**CHANGE
ORDER****FORT BEND COUNTY
ENGINEERING**

PROJECT:
Bellaire Blvd. from 1464 to San Pablo Drive Paving
and Drainage Improvements

CHANGE ORDER NUMBER 04
DATE 4/04/2018
PROJECT NUMBER 13202
CONTRACT FOR 3,772,635.08
CONTRACT DATE 3/28/2017
FBC PURCHASE ORDER NO 151499

CHANGE ORDER REQUEST #4

BELLAIRE BLVD
PLAN AND PROFILE
STA 35+00 TO STA 40+00

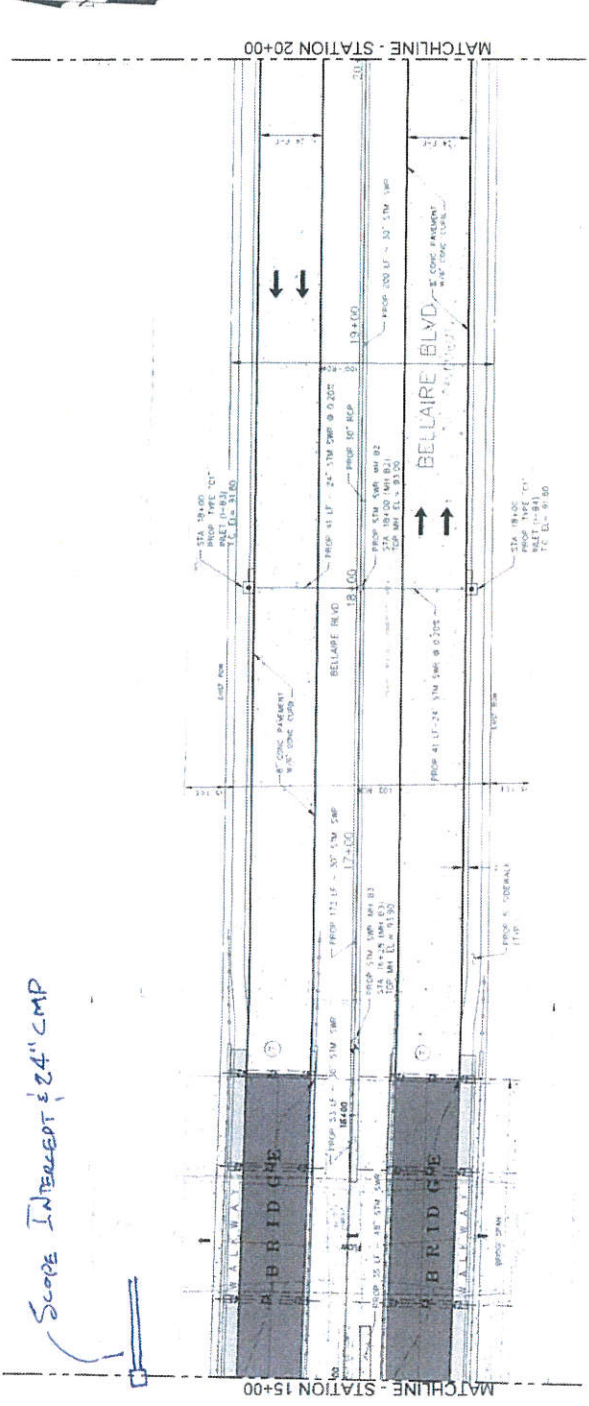
SCOPE INTERCEPT 24" CMP
